Basis for Reaction-Impregnation Shim Plan, MBH08/09

Reaction Shim Plan for MBH08/09

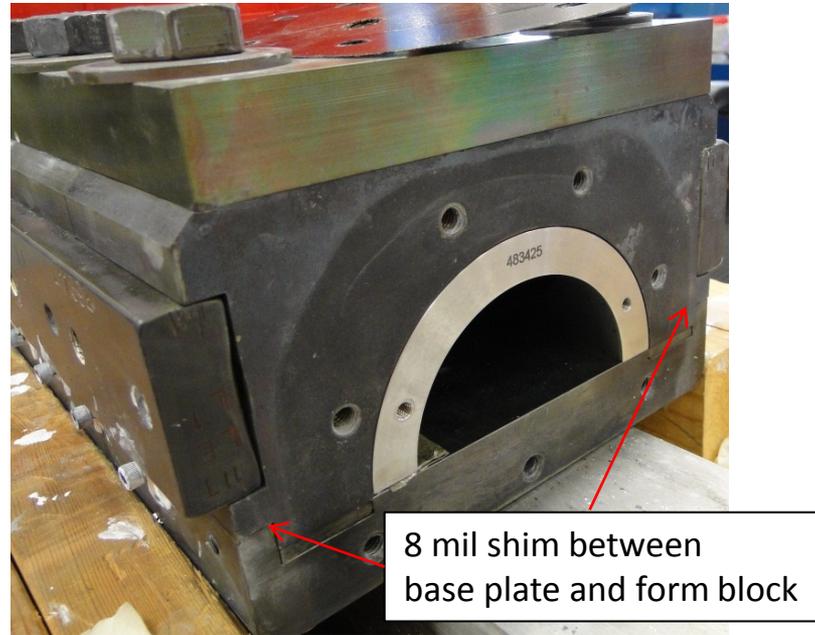
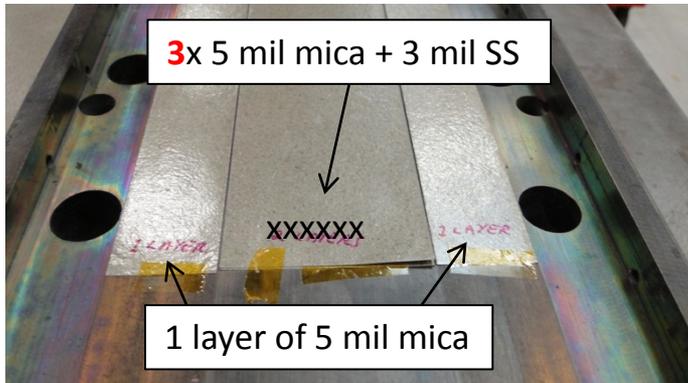
Reduce curing shim by 0.2 mm (8 mils). Inner curing shim was +1 mm, Outer was +1.5 mm.
Increase reaction/impregnation cavity by 0.2 mm (8 mils)
→ Larger azimuthal coil by 0.2 mm?

Revised reaction assy, MBH08/09

Impregnation Shim Plan

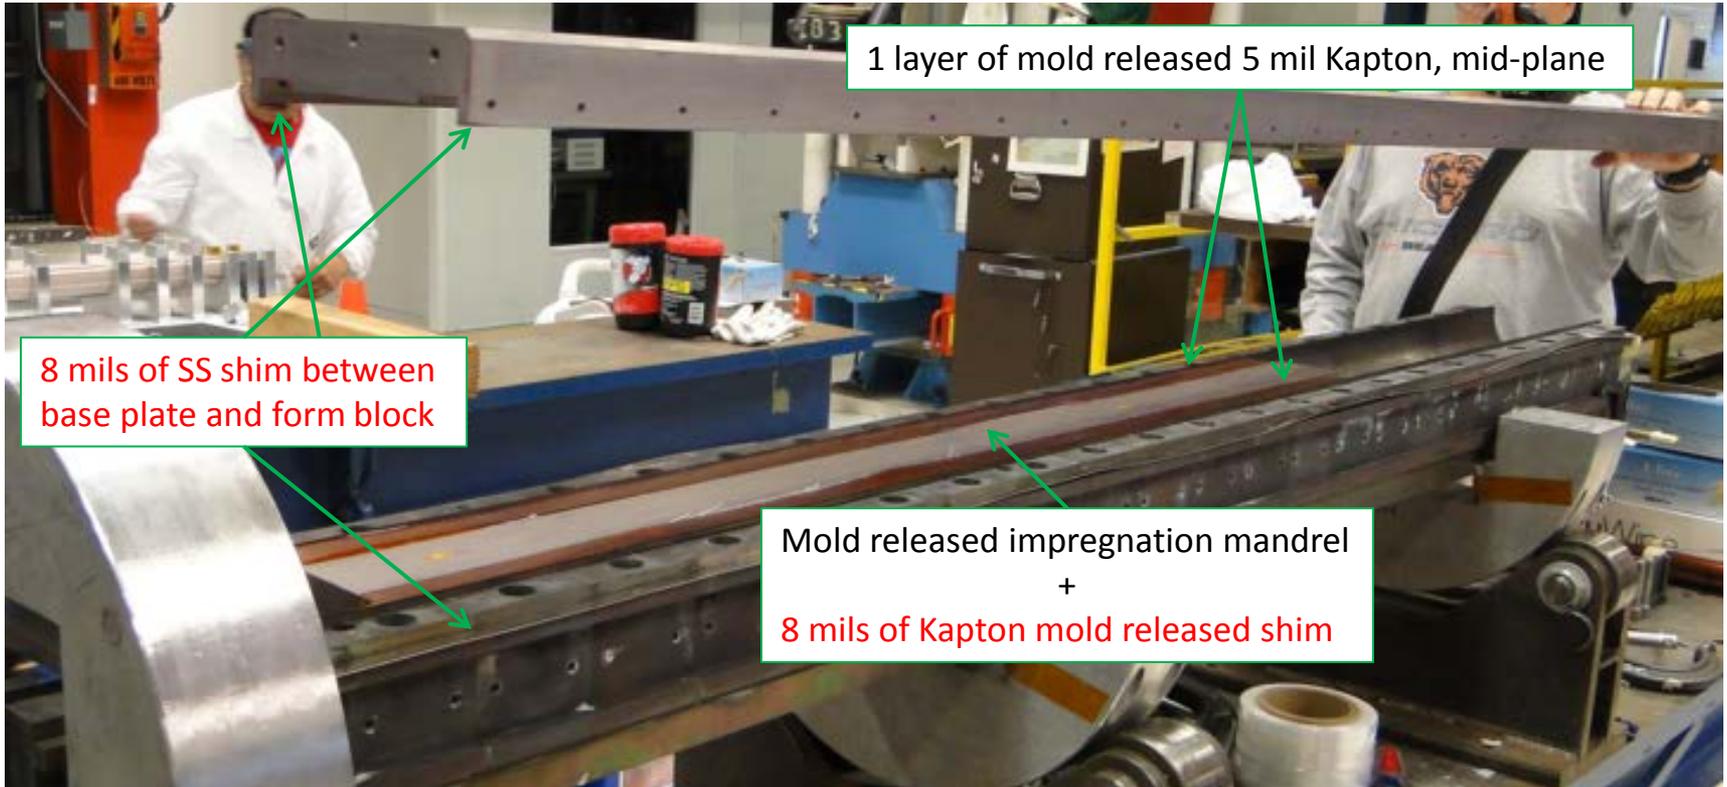
Reminder to flip VT 180°

Revised impregnation plan, MBH08/09
